UNITED STATES  
NUCLEAR REGULATORY COMMISSION  
WASHINGTON, D.C. 20555-0001

November 30, 1995

APPLICANT: Westinghouse Electric Corporation  
PROJECT: AP600  
SUBJECT: SUMMARY OF MEETING TO DISCUSS AP600 REACTOR SYSTEM DESIGN

**Figure 1**  
**PRHR Valve Opening Position**  
**Analysis Model vs. Expected Response**

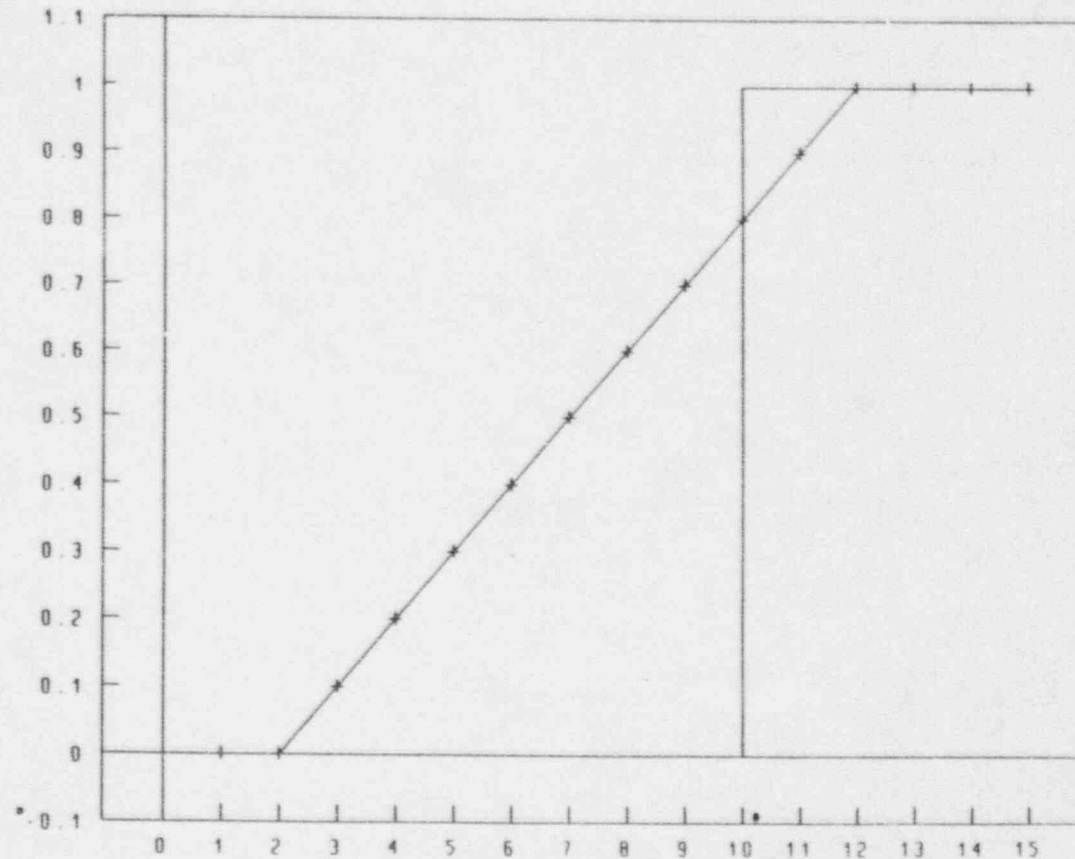
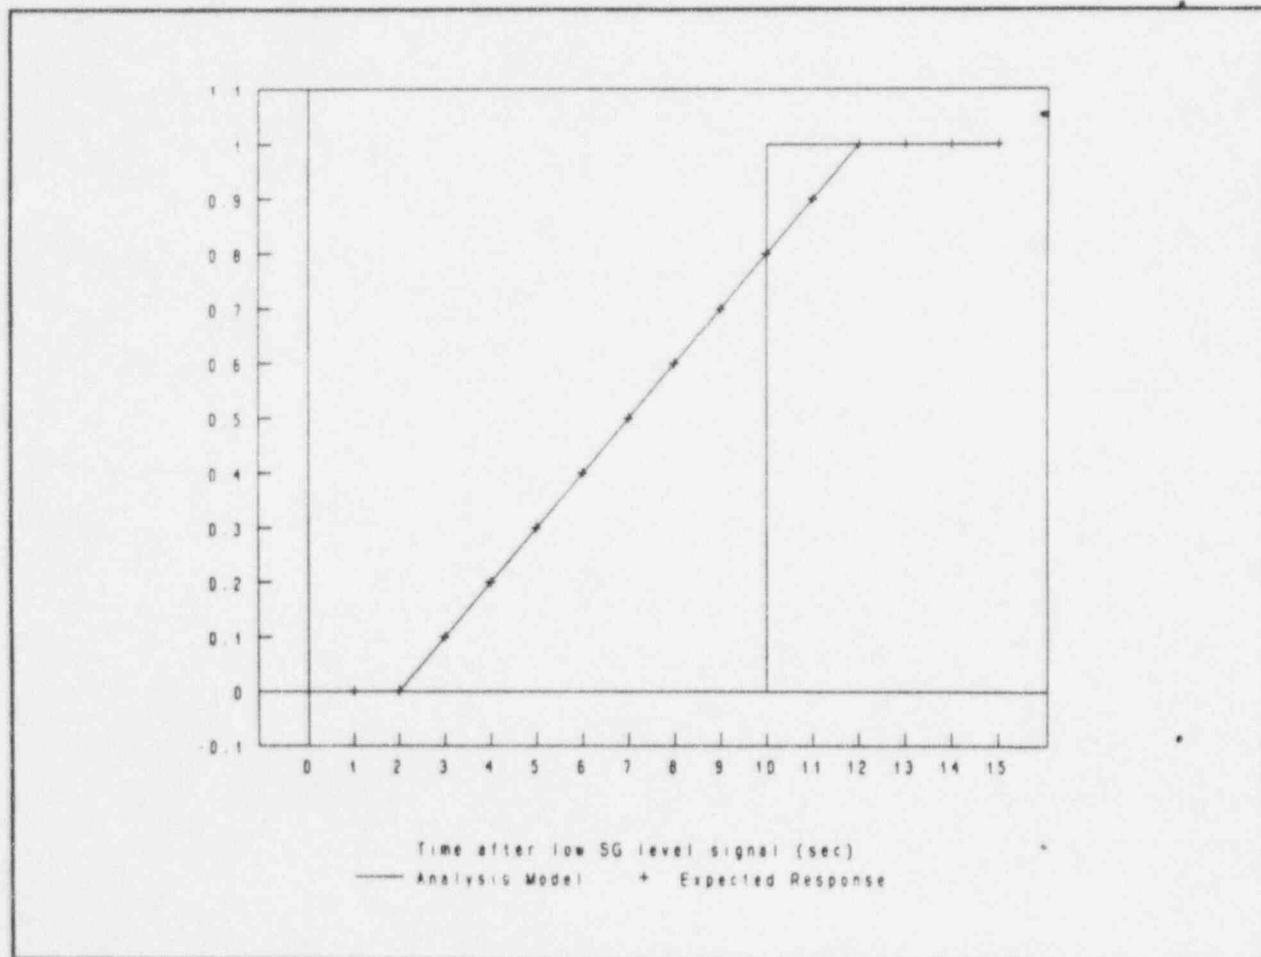
- 7.c It is said (item 8) that since a conservative low DAS wide range SG level analysis setpoint is assumed, no additional delay on this signal is assumed. How do you determine that overall result is still conservative as the DAS setpoint conservatism may not be large enough to compensate for omission of signal delay time? What are the actual DAS actuation setpoint and signal delay time?
- 7.d The PRHR HX valves are assumed to be fully open 10 seconds after the low wide SG level is reached. Does 10 seconds cover the signal delay and valve opening delay times.

The PRHR valve opening position assumed in the ATWS analysis is compared to the expected PRHR valve opening position in Figure 1 below. In Figure 1,  $t=0$  is considered to be the time at which the low wide range SG level DAS setpoint is reached. In the ATWS analysis, the PRHR valve was assumed to fully open according to a step function 10 seconds after the low wide range SG level DAS setpoint was reached. The expected response would include a signal processing delay before the PRHR valve received the signal to open. The maximum signal processing delay is expected to be about 2 seconds. Upon receiving the actuation signal, the PRHR valve is expected to open linearly over 10 seconds.

As shown in Figure 1, the PRHR valve opening position was largely underpredicted from 2 to 10 seconds after the low wide range SG level DAS analysis setpoint was reached. From 10 to 12 seconds after this signal, the PRHR valve opening position was slightly overpredicted. Overall, the integrated response of the PRHR valve was clearly underpredicted in the ATWS analysis.
